Please find this letter and the accompanying documents as addenda to the causeway plan submitted in April. We trust these addenda address the remaining concerns regarding the fresh water causeway required for the Jericho Diamond Mine development.

**RE: Addendum to the Fresh Water Causeway Design and Construction Plan
Jericho Diamond Project, Nunavut**

This letter is submitted to Tahera Diamond Corporation (Tahera) as an addendum to our document of April 2005 entitled "Specification for the Fresh Water Intake Causeway." Questions and comments related to the April document were provided to the Nunavut Water Board by Indian and Northern Affairs Canada (letter from Robert Eno, dated May 12, 2005) and Fisheries and Oceans Canada (letter from Derrick Moggy, dated May 31, 2005). This letter responds to issues raised by intervenors that are applicable to the design and construction aspects of the causeway. Issues specific to the fresh water pumping system, fish protection screen and pipeline are addressed in documents prepared by Hatch and submitted to Tahera under separate cover.

CARAT LAKE WATER INTAKE
PLAN AND SECTIONS
PIPING DESIGN

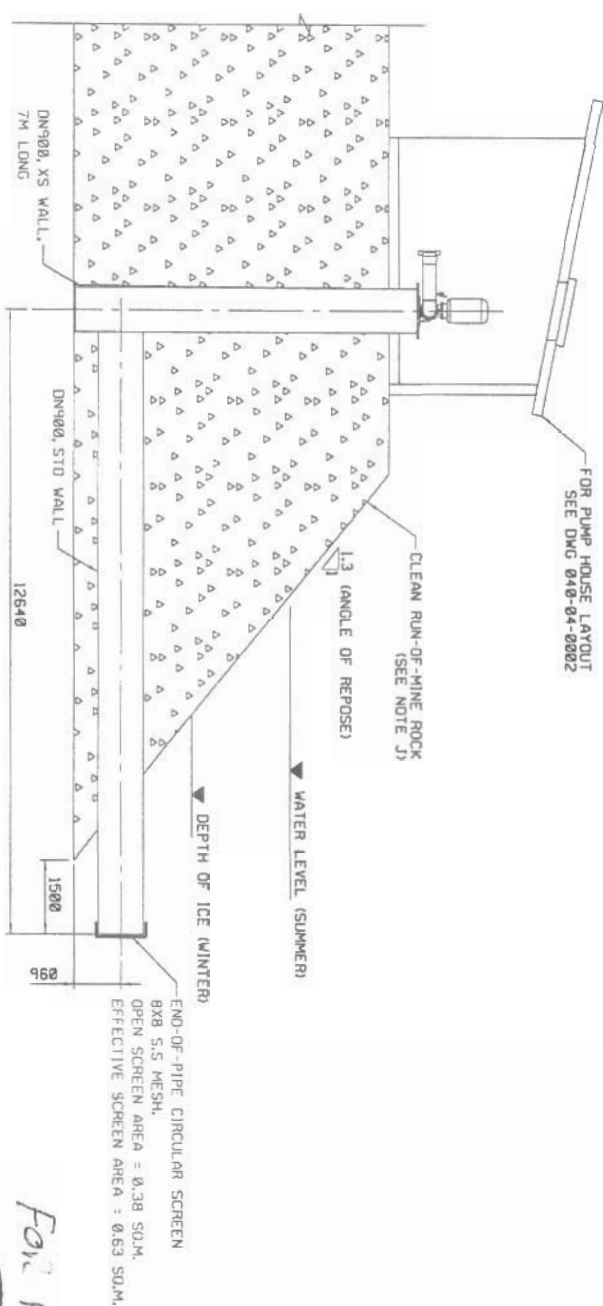
4. Both Alternatives Shown on Drawing

The Hatch drawing that showed two alternatives for the design of the intake pipe has been revised and is attached to this letter as Figure A3. It shows only the alternative presented and approved as part of the water licensing process.

As regards the INAC reference to Alternative 1, Tahera initially recommended the use of the Alternative 1 design. Tahera was, however, required to modify its plans based on the requirements of Fisheries and Oceans Canada. While we concur that many issues involving ice and construction would disappear with the implementation of the Alternative 1 design, the approved design is the Alternative 2 design (Figure A3).
